PUBLIC INTEREST REVIEW FOR GROUNDWATER APPLICATIONS

TO: Water Rights Section Date 9/25/2018  
 FROM: Groundwater Section Phillip I. Marcy and Justin Iverson  
Reviewer's Name  
 SUBJECT: Application G- 18633 Supersedes review of 6/22/2018 (revisions highlighted)  
Date of Review(s)

DATE: 9/25/18  
TO: File G-18633  
FROM: Justin Iverson  
SUBJECT: Evaluation of stage variations of Brownlee Reservoir with respect to hydraulic connection with MALH 54422

Figure 1: Screenshot of webpage showing stage elevation of Brownlee Reservoir, Sept 2014 to present<sup>1</sup>

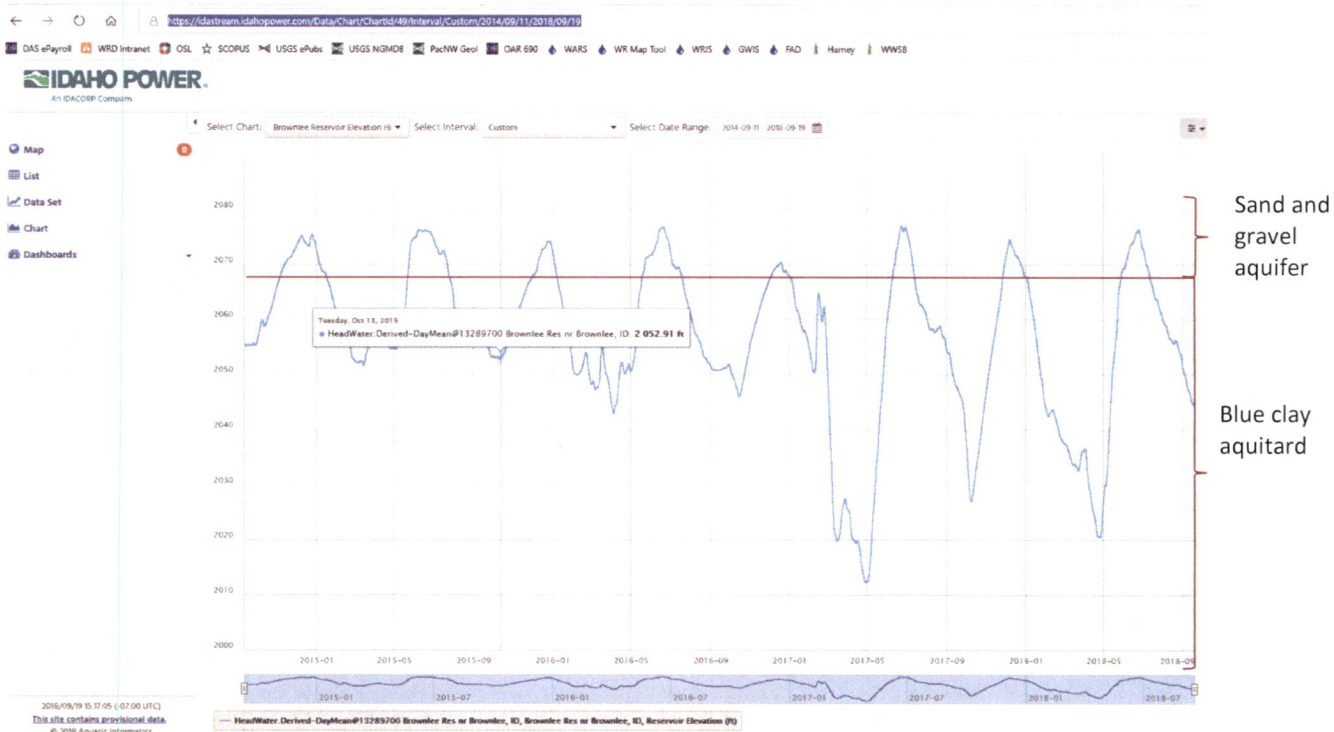
Idaho Power, which operates the dam, provides historic stage elevation data for Brownlee Reservoir on their website<sup>1</sup>. Figure 1 is a plot of the reservoir elevation for approximately the past 4 years. The pool elevation of Brownlee Reservoir ranges from a maximum of approximately 2077 ft amsl (6/16/17) to a minimum of approximately 2013 ft amsl (5/2/17) over that period. The spillway elevation of the dam corresponds to the highest recorded water levels over the past several years, indicating that the edge of the digitized pool on the NHD coverage and USGS topographic map shows the greatest extent of the pool. This resulted in the shortest possible measured distance to the subject well in the groundwater technical review of 6/22/2018.

Figure 2: Screenshot of MALH 54422 underlain by most recent aerial image taken on 10/14/2015

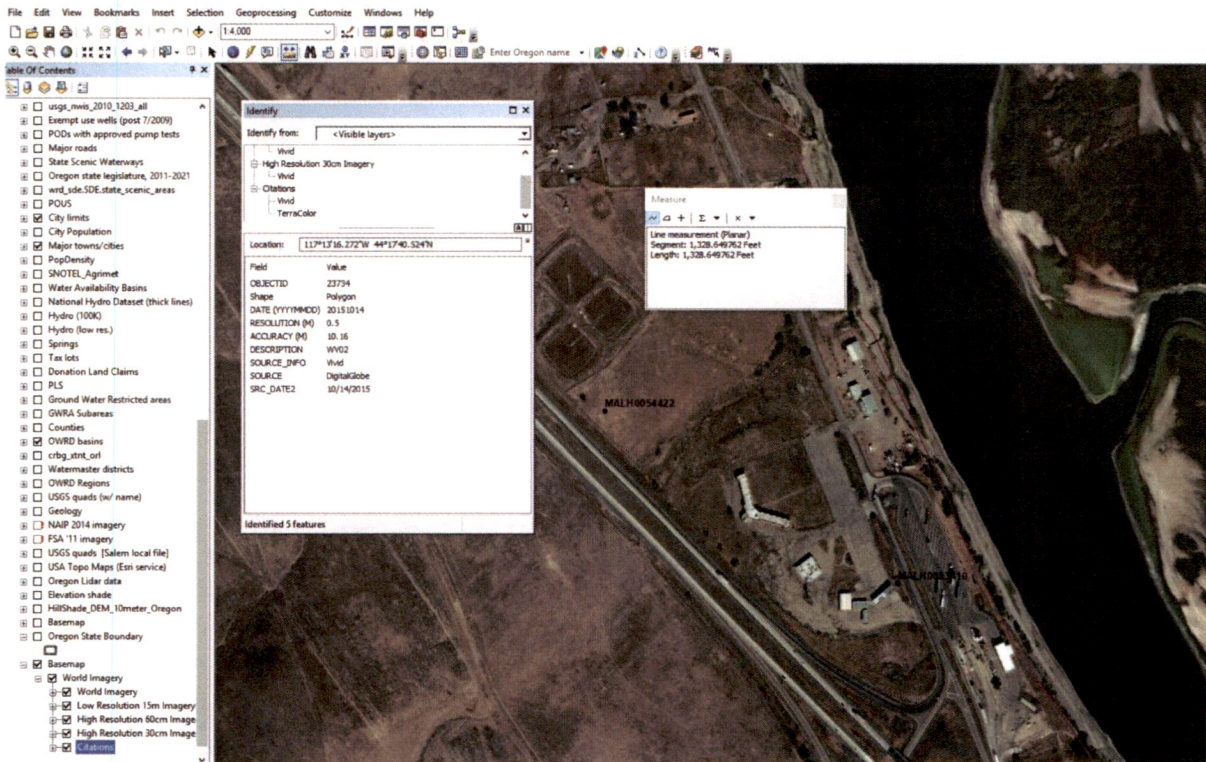
The most recent readily available aerial image of the site (Figure 2) was taken on 10/14/2015. This date corresponds to a mean daily pool elevation of approximately 2053 ft amsl, as shown on Figure 1. The measured distance (using GIS software) from the well MALH 54422 to the edge of the pool as shown in this aerial image is approximately 1329 feet, which is greater than ¼ mile.
